Urban Design & Architectural Report

38 Pacific Highway

This document responds to the Document "Pre-DA Lodgement Notes – June 2025" issued by Lane Cove Council. This Urban Design and Architecture report addresses items in this document, including clarifications relating to FSR, GFA, building height, heritage, building class and DCP requirements.

1.5.2 NSROC Design Review Panel Meeting Comments Summary

1.4.2 Recession plane & solar access

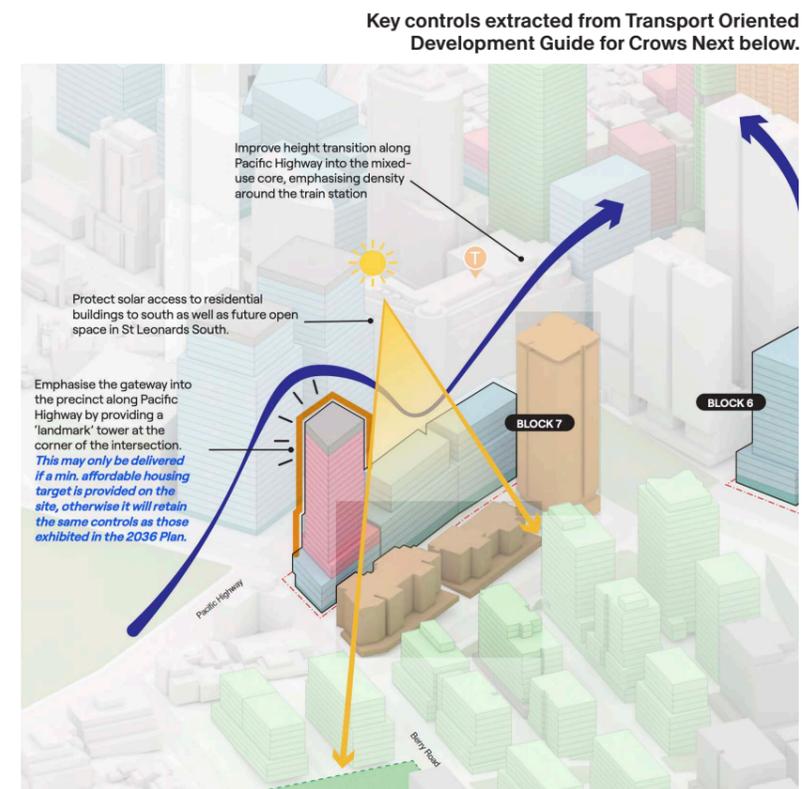
The TOD does not specify a 32° sloping height plane control. Instead, it includes objectives for solar access that override the Lane Cove DCP's Figure 14: Section AA of Block A. The proposal at 38 Pacific Highway has elected to maintain a stepped form down to the Marshall Lane side of the building to preserve solar access to Southern neighbours. While the lift overrun sits above the notional 32° plane, the overall building adopts a stepped form to the south, specifically to preserve amenity for neighbouring properties. Solar analysis confirms compliance with relevant solar access benchmarks.

TOD does not specify a recession plane. Current building form meets and exceeds solar amenity requirements for Southern neighbours.

1.7 Lift core and plant integration

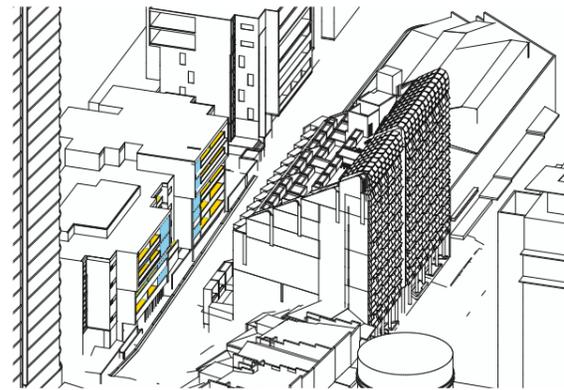
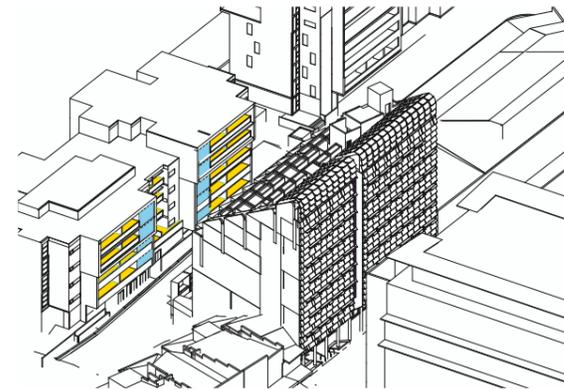
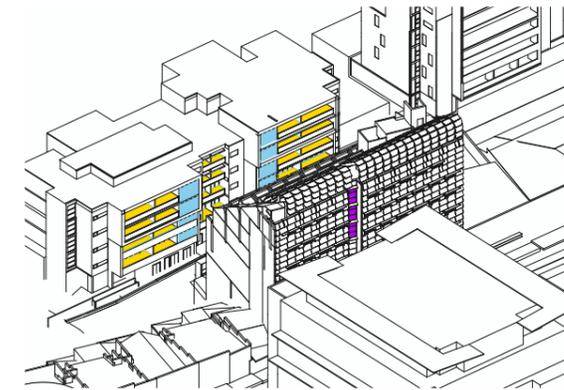
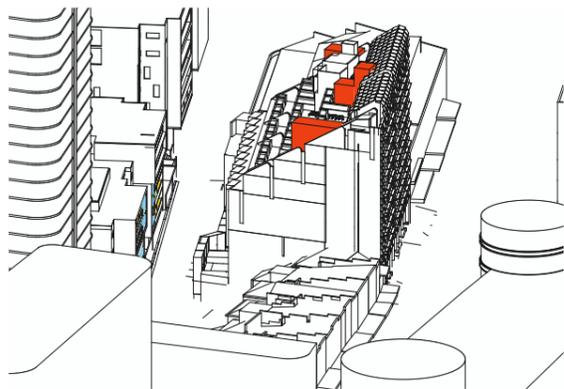
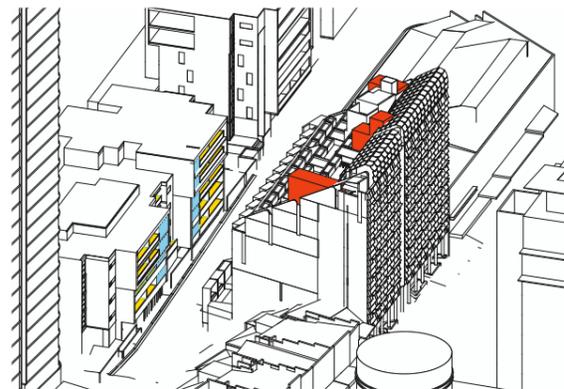
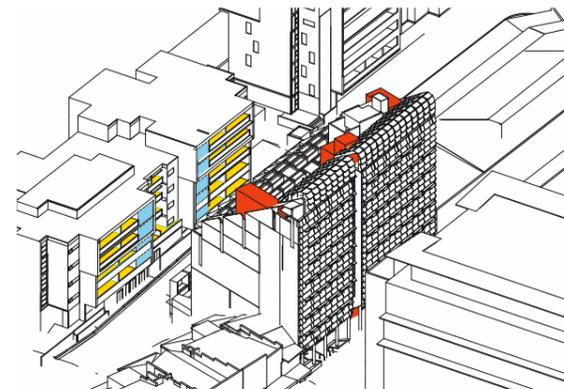
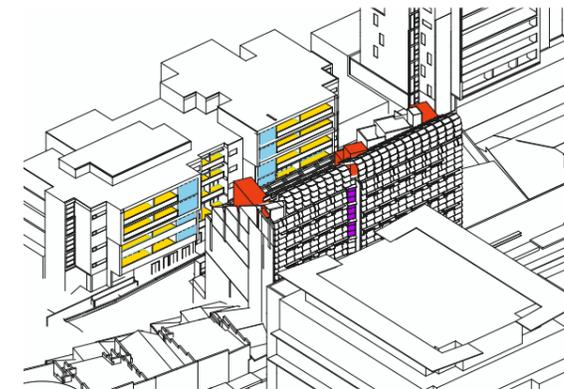
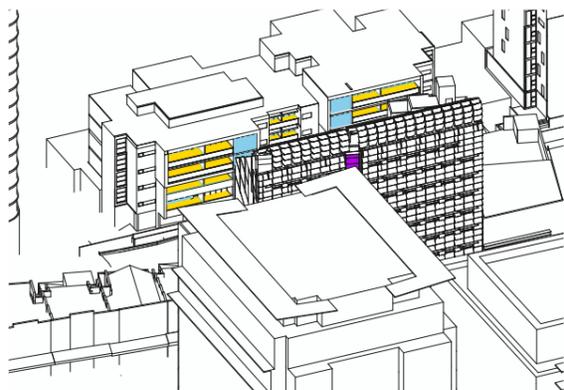
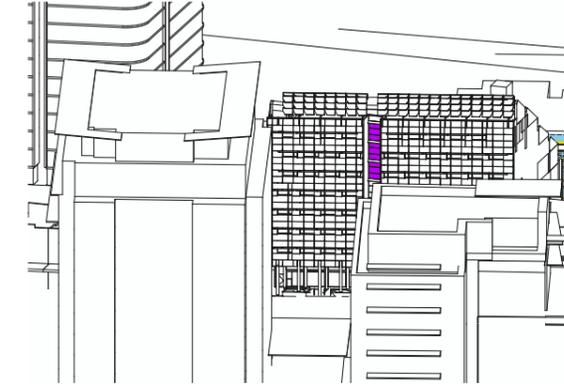
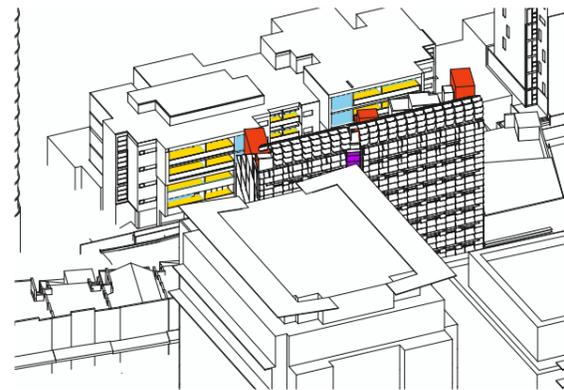
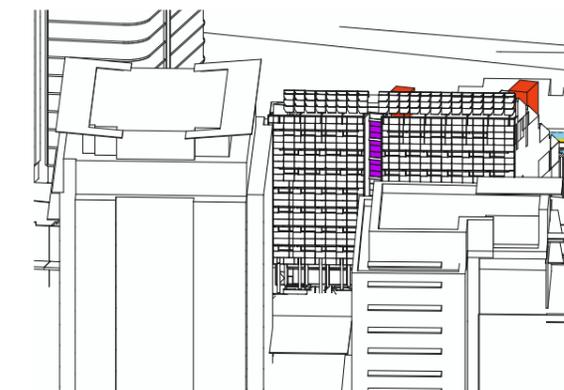
2. Built Form and Scale	Lift core and rooftop services appear as standalone elements.	Diagrams are provided to explain core placement and potential impacts.

6. Amenity	Through-site link should be co-located with core and fully accessible.	Access is provided via a stair from Marshall Lane to Pacific Highway.
	Core location should be rationalised.	Alternative core layouts were tested and rejected due to impacts to neighbouring properties. Current location supports daylight to lobbies and optimal fire stair positioning. Justification diagrams included.
	Reference to ADG and co-living principles (in error).	The development is now clearly defined as hotel use. ADG does not apply. SEE and reports updated to remove co-living references.

At rooftop level, a cluster of volumes accommodates the building's mechanical exhaust systems and lift overrun. Their location is the result of multiple, overlapping constraints: mechanical exhaust outlets must be sited at least 6 metres from any side boundary and from any building openings, as indicated by the orange zones on the plan and elevation diagrams, while lift overruns must be positioned to provide direct access to the uppermost floor.

Relocating the service and vertical circulation cluster further East, within the permissible area noted in blue on the diagram, would result in additional overshadowing to the neighbouring residential buildings at the South (refer to additional solar diagrams overleaf). The current configuration prioritises solar access to the neighbouring apartments over the uninhabitable roof space of the commercial building to the West, seeking to achieving a balance between technical requirements and contextual sensitivity.

As visible in the eye of the sun diagrams pictured, there is no additional overshadowing at 9, 10, or 11am, it does cause additional overshadowing from midday until 2pm.

1.7.1 Solar and form analysis

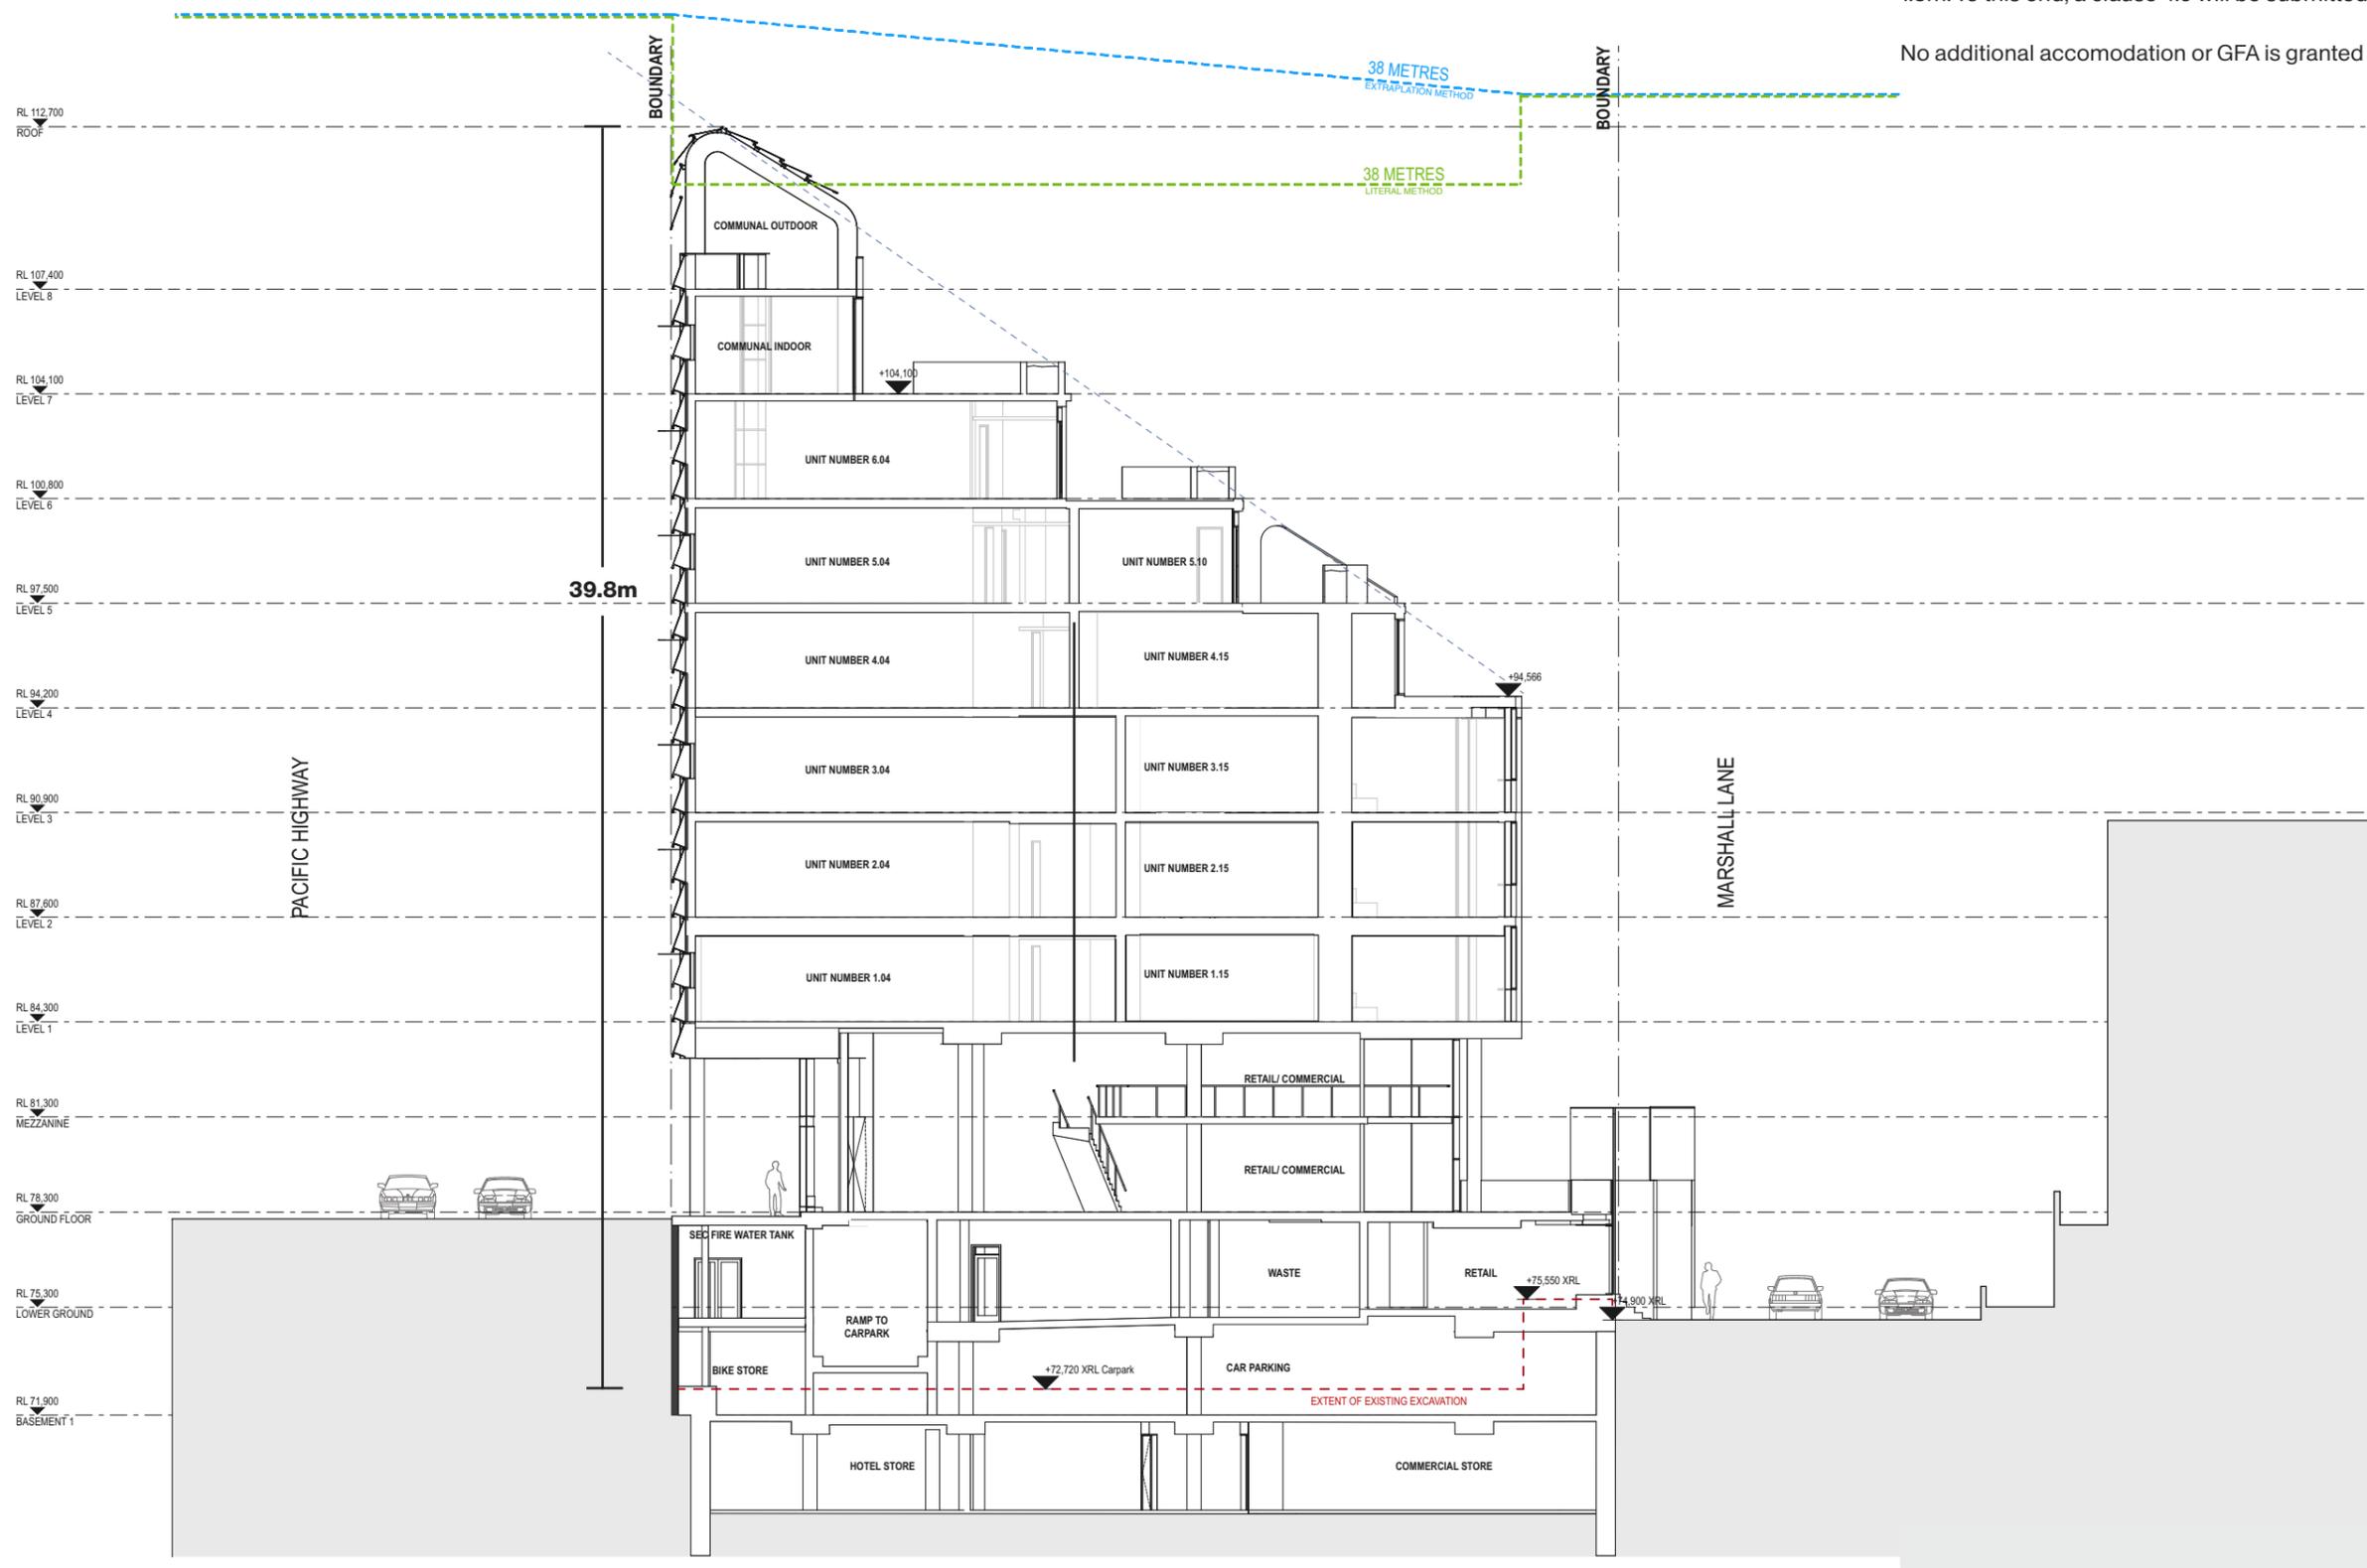
The suggestion by the design review panel to move the fire stairs South to within the circulation space would result in greater impact, as the form of the fire stair is moved away from the northern, taller side of the building, and therefore protrudes further from the sloped building form.

As part of the concept design, various core locations were investigated for their impact to the neighbouring residential properties, building efficiency and compliance. A central core was ruled out for its additional impact to overshadowing, further protrusion through the recession plane, and the requirement for an additional building form at the rooftop level, due to the requirement for two stairs, the exhaust stack, and the lift core itself.

1.9 GFA and FSR

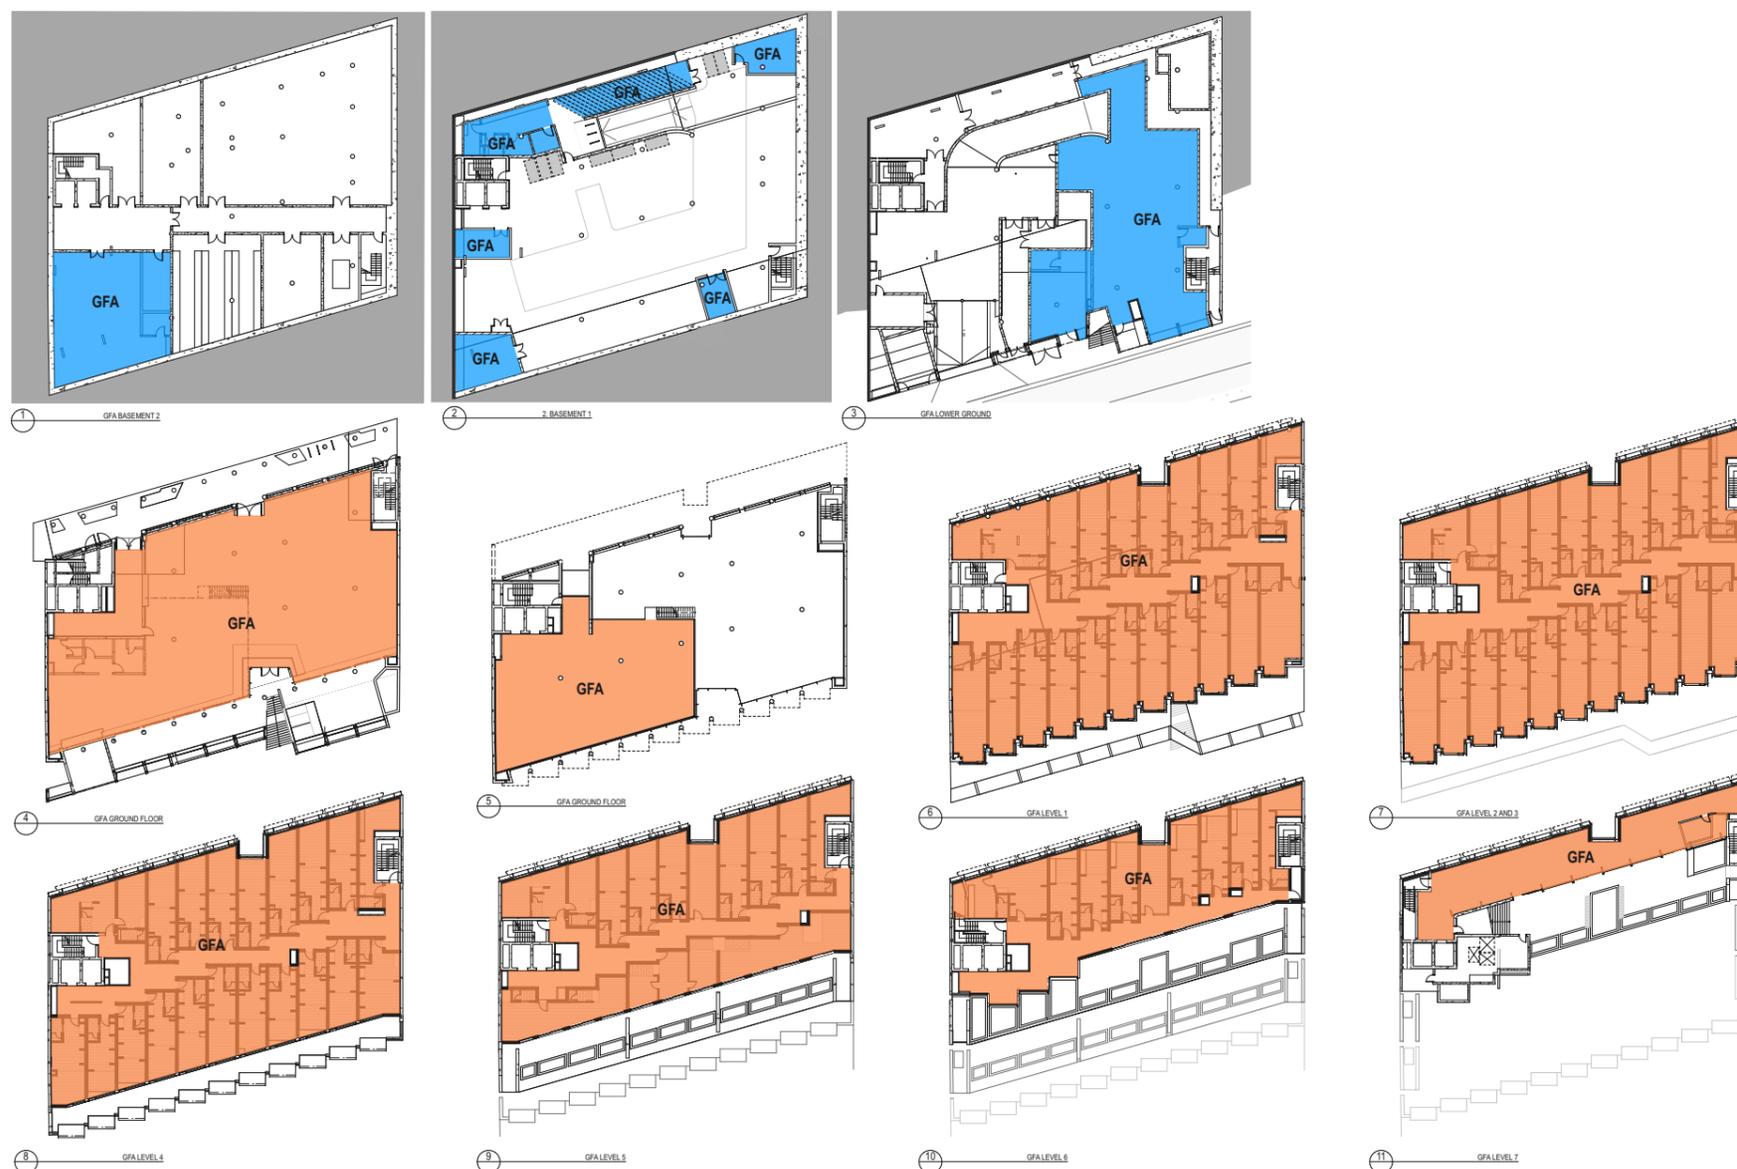
Gore Hill Memorial Cemetery is a State Heritage Item—Statement of Heritage Impact (SoHI) required	SoHI to be provided by TZG Heritage.
Confirm gross floor area (GFA) inclusions and exclusions according to LEP definitions	GFA schedule and plans have been updated. Basement areas included in FSR where not exempt under LEP definition.
Public domain upgrades (e.g. planting, pavement) along Pacific Highway recommended but outside DA boundary	Noted. Acknowledged as desirable but outside site boundary and scope of works. Support in principle for future Council-led improvements.
Shared zone treatment for laneway encouraged to enhance precinct connectivity	Laneway shared zone is outside DA boundary. Not included in works, but supported as future public domain opportunity.
Clarify rooftop lift core and plant design to avoid bulk/dominance	Explanation of core and plant layout provided. Investigation conducted into centralised core location. Location preserves solar access to neighbours and satisfies mechanical requirements.

The proposed development achieves an FSR of approximately 5.24:1. This figure has been amended to include lower ground level spaces such as bicycle parking, plant rooms, end-of-trip facilities and storage that are technically above ground level (existing) due to the site's previous excavation.

In response to Council's interpretation of existing ground level, the FSR calculations have been revised to include these areas in accordance with the LEP definition of gross floor area. A Clause 4.6 variation will be submitted to address the resulting technical exceedance.
